CITY PLANNING COMMISSION

APPLICATION: 1. Environmental Determination
2. Special Permit to develop a drive-thru window in an existing restaurant in the Heavy Commercial (C-4) and Office Building (OB) zones. (Sec. 2-B-(13))

LOCATION: 5425 Fruitridge Road

PROPOSAL: The applicant is requesting the necessary entitlements to develop a drive-thru service in an existing fast food restaurant.

EXHIBIT 'A'

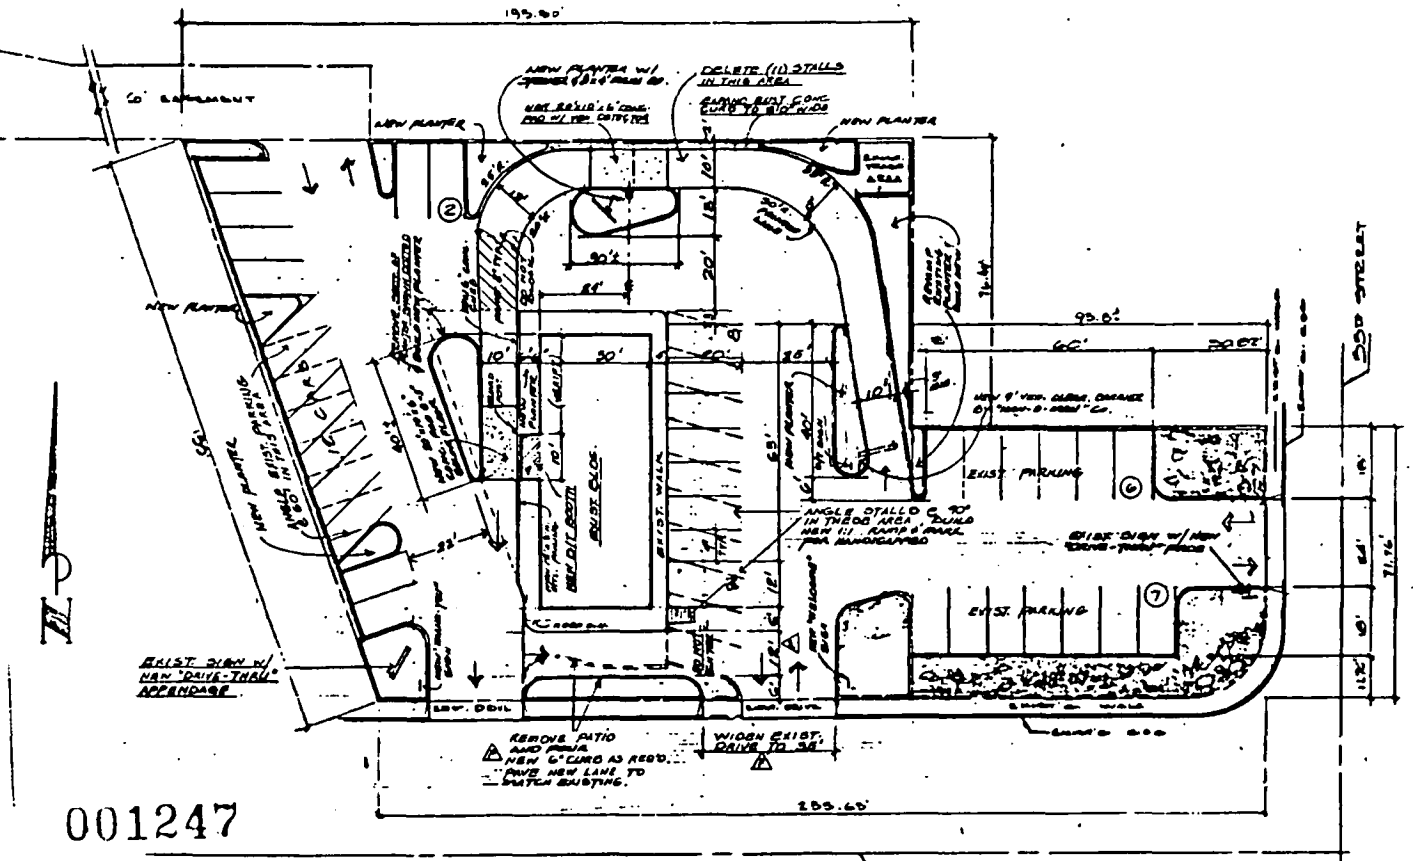
Staff does have concern over the design of the drive-thru lane as proposed, due to the close proximity of this lane to an adjacent residence. In an effort to address concerns over the design of this project, staff recommends the planter area on the northeast corner of the site adjacent to the proposed drive-thru lane be increased to a minimum width of eight feet. This can be accomplished by relocating the drive-thru lane to the west, reducing the menu board island and using compact car spaces along the east side of the restaurant (see revised plan Exhibit B).

EX 'B'

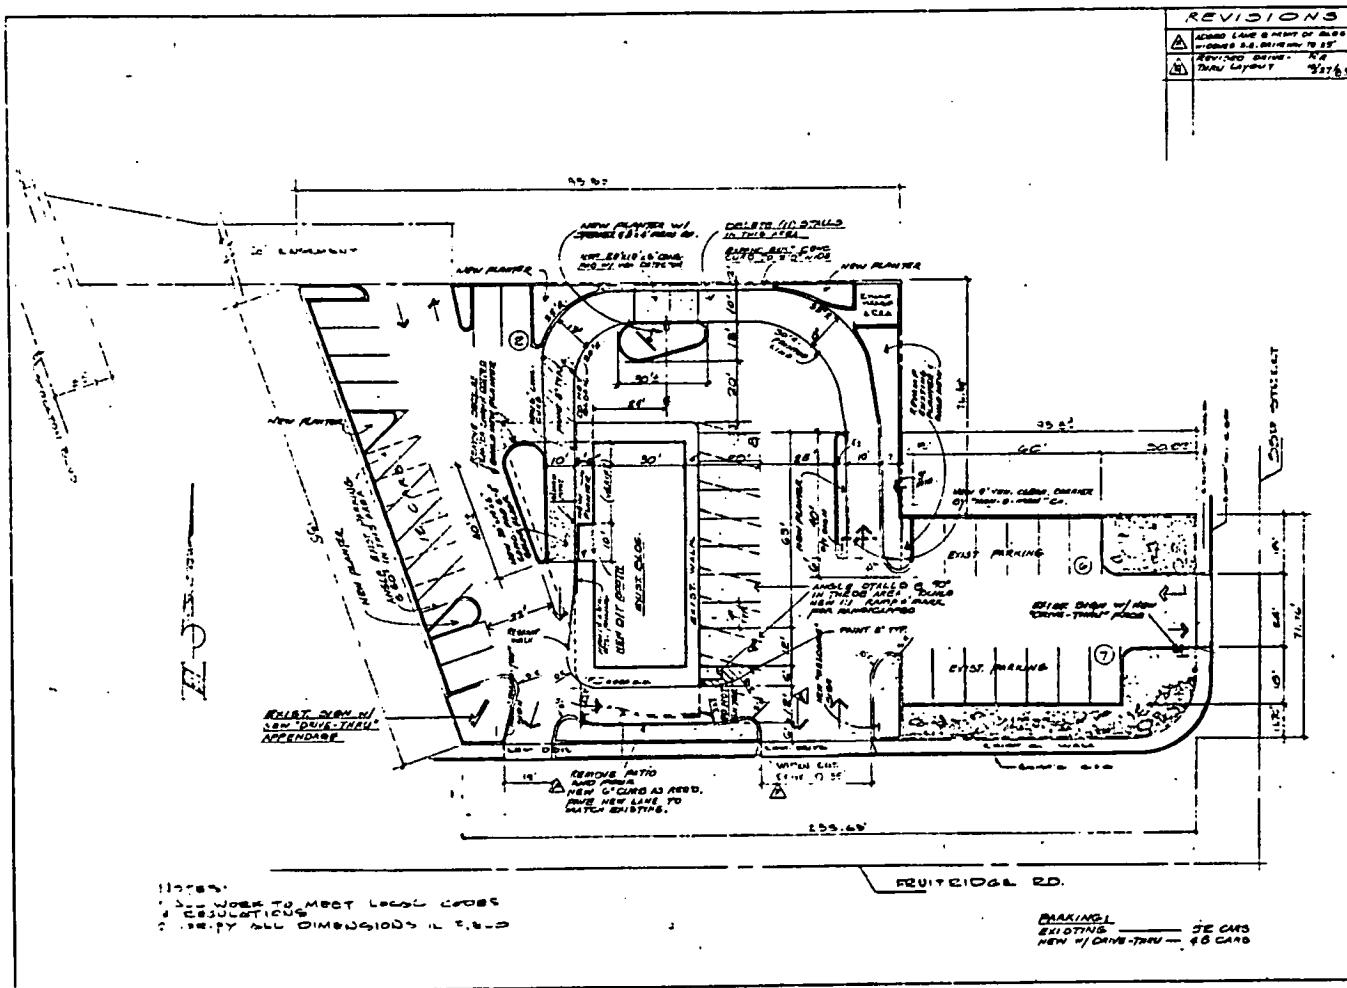
5. The applicant's proposal was sent to the City Traffic Engineer, Fire Department and Building Inspections. The Traffic Engineer indicated concern over the drive-way entrances and the proposed return lane in front of the structure. The Traffic Engineer requested modifications necessary to minimize on-site traffic problems, and the applicant has redesigned the plan to address these concerns (see attached Exhibit B).

- b. The drive-thru service and traffic patterns shall be developed according to the revised plans in Exhibit B. These plans shall be reviewed and approved by the Planning Director and Traffic Engineer prior to issuance of building permit;
- c. The four-foot masonry wall on the northeast property lines shall be extended to six feet in height as measured from the grade of the subject site. Revised plans shall be submitted for Planning Director review and approval prior to issuance of a building permit (see Exhibit B);
- d. The applicant shall install a light shield to those light fixtures adjacent to the residences to prevent light spillage into the residential yards.
